**AMENDMENTS TO THE DRAWINGS**

Amendment filed June 7, 2006

Appln. No. 10/052,459

FIG. 1

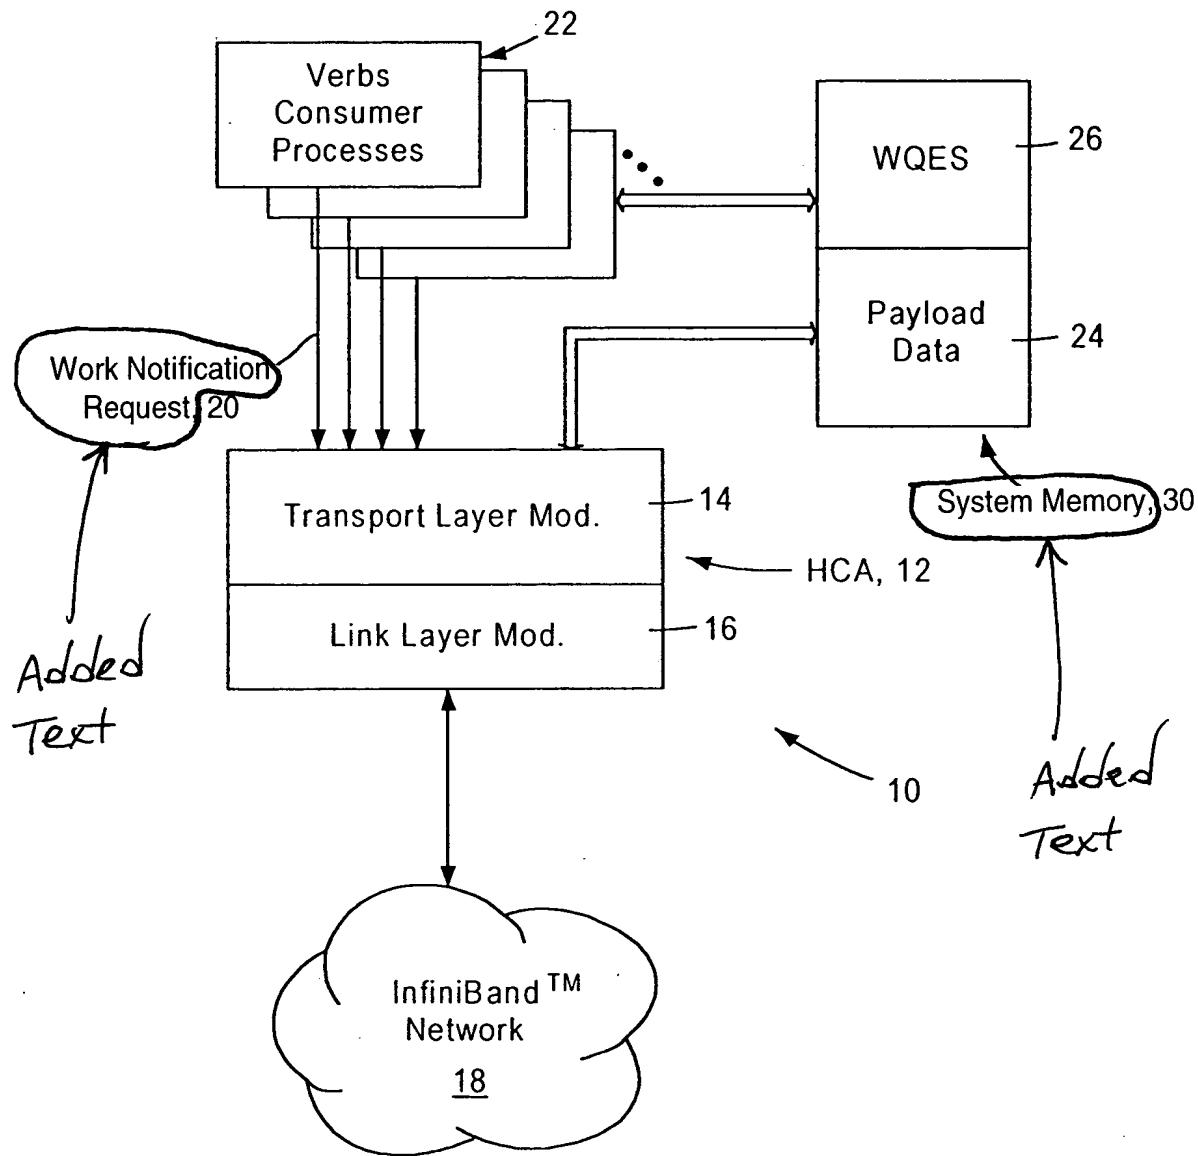
The attached two (2) sheets of drawings includes changes to Figs. 1 and 2. This two (2) sheets replace the original sheets that include Figs. 1-2. Figs. 1 and 2 include added text as suggested by the Examiner.
